#### 183rd session

## Proposal for a new 05 series of amendments to UN Regulation No. 41 (Noise emissions of motorcycles)

### Submitted by the Working Party on Noise and Tyres\*

Figure 1  
**Test track layout with dimensions in meters**

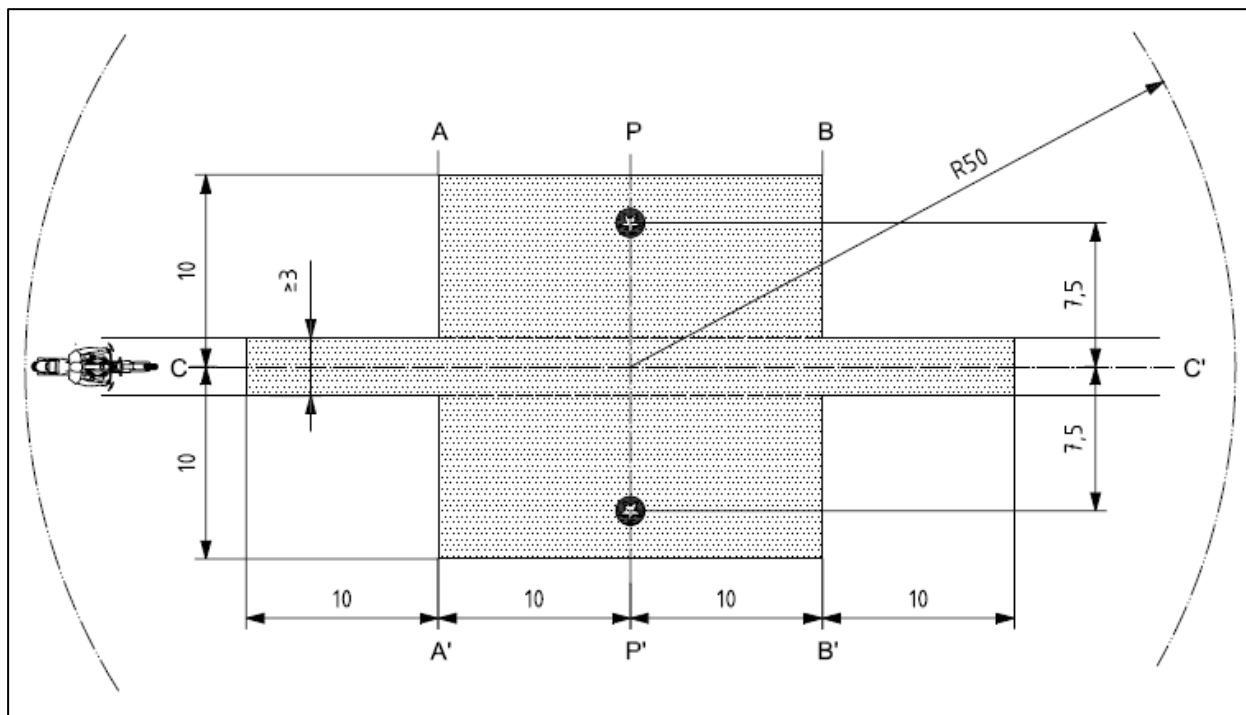
The path of the centreline of the vehicle shall follow the line CC' as closely as possible throughout the entire test, from the approach to line AA' until the rear of the vehicle passes line BB' +20m (see Annex 4 – Figure 1)."

The maximum A-weighted sound pressure level "L" indicated during each passage of the vehicle between AA' and when the rear of the vehicle passes BB' +20m (see Annex 4 – Figure 1) shall be reduced by 1 dB(A) to account for measurement inaccuracy and mathematically rounded to the nearest first decimal place (e.g. XX.X) for both microphone positions. If a sound peak obviously out of character with the general sound pressure level is observed, that measurement shall be discarded.

Figure 1, amend to read:
